# TOYOTA

## Service Bulletin

Ref. No. : EG-5010

### **Subject : Handling of DTC "P0420/P0430" Case by Models**

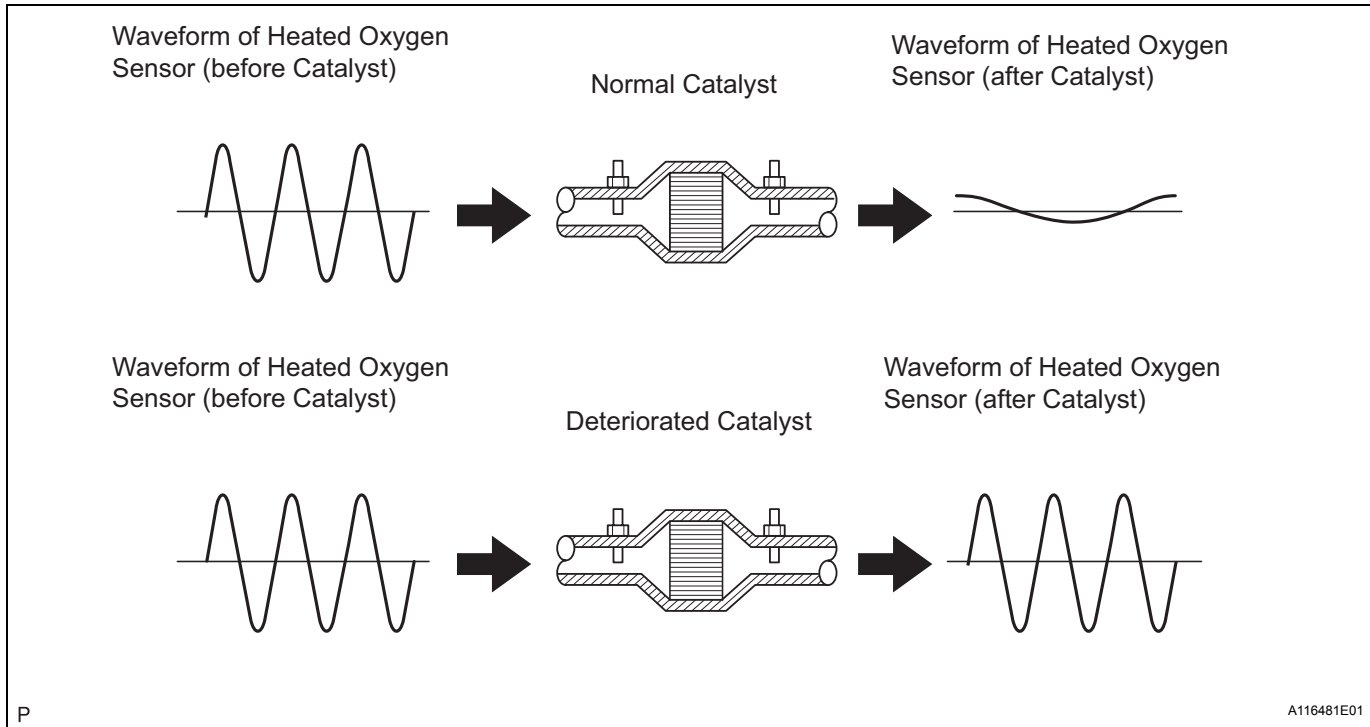
## 2. Inspect Catalytic Converter efficiency by measuring O<sub>2</sub> sensor signals, and replace converter if necessary

(a) Refer to the oxygen sensor output signal waveforms below.

- In case of normal operating catalyst, the output signal of the rear heated oxygen sensor shows very slow activity.
- If the catalyst has deteriorated, the output signal of the rear heated oxygen sensors becomes very similar to that of front heated oxygen sensor.
- If, based on the sensor signals, you judge catalyst is not working properly, replace catalyst and not the O<sub>2</sub> sensors.
